# NFPA Document Proposal Form

1. (a) NFPA Document Title National Electrical Code International Electrical Code Series NFPA No. & Year NFPA 70: NEC 2011

(b) Section/Paragraph 210.12 Arc-Fault Circuit-Interrupter Protection

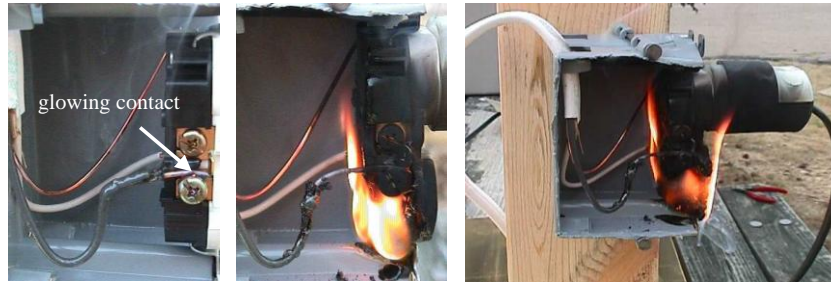
Case:

The fire hazard resulting from a glowing contact at UL 498 Listed receptacle terminals is well know and documented. See photos below.
